CODE ANALYSIS

2019 CBC Accessibility & 2010 ADA Review

for Existing S-1 Building Use/suite

@ 3060 Commerce Way

EXISTING FLOOR PLAN

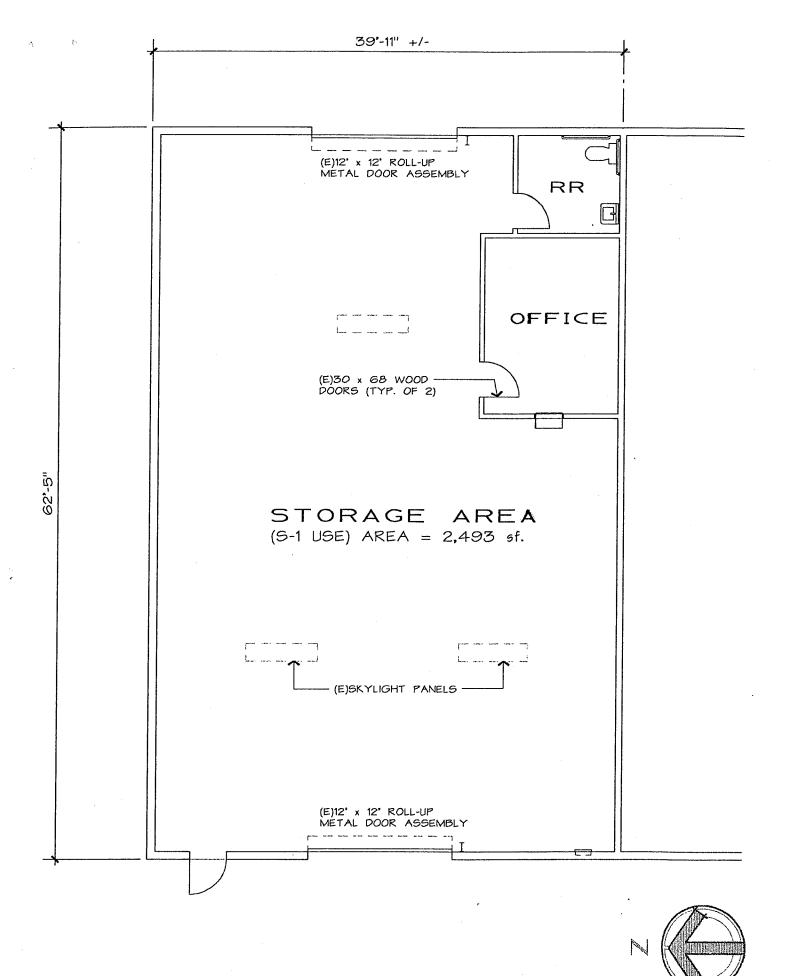
<u>Parking lot/stalls</u>: Existing Disabled parking stalls to not comply with current Code requirements. Striping & Signage needs to be upgraded &/or installed where missing. See attached code section 11B-501 (pgs 573 – 576, 467 & 468) for parking stall requirements and the 9' wide x 18' long Van unloading aisle, etc. The "Van Accessible" sign is missing & the Tow away Sign needs to be installed at Driveway entrance.

Restroom: "All Gender" Restroom Door & Wall Signage needs to be installed per 2019 CBC Accessibility requirements.

Lavatory Sink needs 18" clearance from wall to center of the sink, could not field verify, due to wet Wax on Floor. Toilet paper Dispenser, Paper Towel dispenser, Soap dispenser & Grad Bars need to comply with 2019 CBC Accessibility requirements as well; and any Exposed Pipes below Lavatory need to be wrapped with insulated covers per CBC 11B-606.5 (see attached page 587).

<u>Water Closet (Toilets)</u>: Centerline of Toilet fixture must be placed 17-18" away from side wall, with seat height at 17-19" max. above finish floor (aff). Could not field verify dimension. All other standard clearances required & appear to be provided. Grab bars seem to be installed per CBC 11B-604.5 standards (see Figures 11B-604.5.1 & 11B-604.5.2 on page 582).

All Controls, Paper Towel, Soap Dispensers, Mirrors & Toilet Seat covers, etc shall be mounted no more than 40" above the finish floor per CBC standards.
